# GROUPGSA

**Subject: Response to Submissions - Eden Street, Arncliffe Mixed Used Redevelopment  
Landscape Architectural**

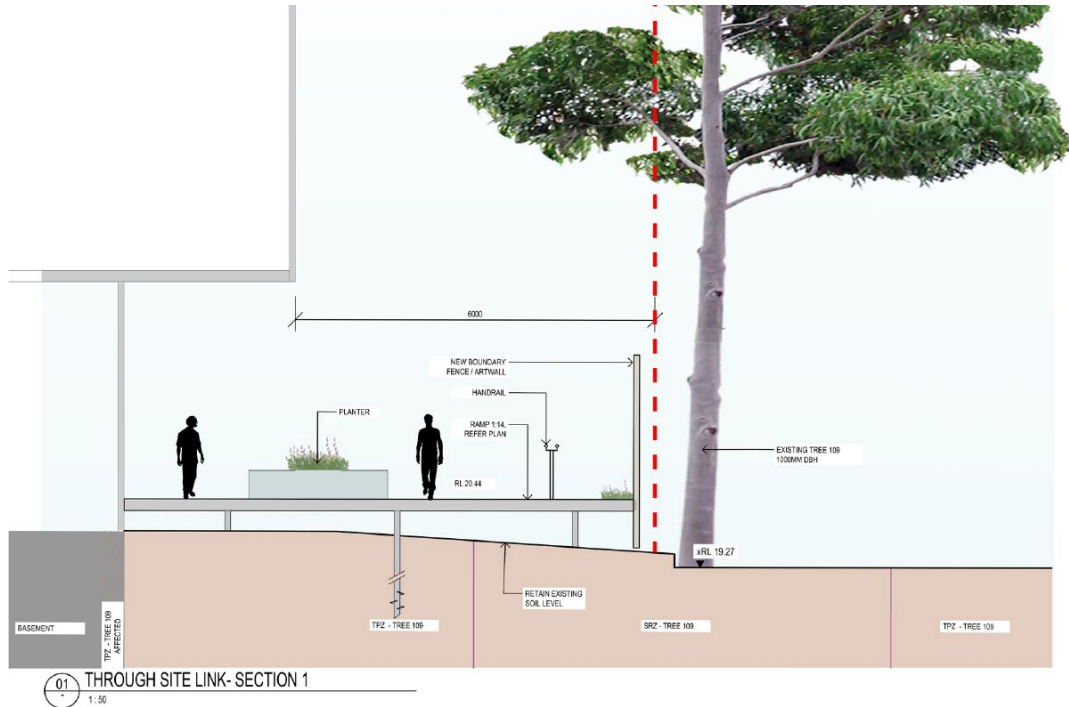
*"In relation to tree 109, the new AIA notes that proposed impacts are sustainable provided there is no excavation within the tree protection zone (TPZ) and that existing structures such as paths, are replaced within the existing footprints. This recommendation is not consistent with amended landscape and architectural plans which show proposed level changes and the installation of new structures including paths, a ramp, boundary walls and raised planters within the TPZ of the tree.*

*EES notes that the previous AIA prepared by Naturally Trees made similar recommendations for the retention and protection of tree 109. In particular, the report recommended that existing levels between the tree and the exploratory trench (as detailed in the report), must remain unaltered and that there is to be no services or built structures placed within this critical zone. This recommendation was informed by a root mapping exercise."*

The latest landscape and architectural design has informed the revised AIA and the final advise that trees 3,44,45,109 and 111, are viable to be retained. The existing levels surrounding tree 109 will be retained and protected following Birds Tree Consulting advice described on the report dated 22/12/21 and as shown on the landscape sections "Through Site Link – Section 1 & Section 2". Refer landscape drawings 180913–DA 9509[6].

The nearest building, basement and pile zone will be limited to the 10% encroachment into the TPZ as highlighted on Birds Tree Consulting report dated 22/12/21. Protective measure will be part of Contractor responsibility during construction. The elevated walkway under tree 109 is designed with screw piles to support the walkway. This has been reviewed and agreed by Birds Tree Consulting as allowable within the TPZ.
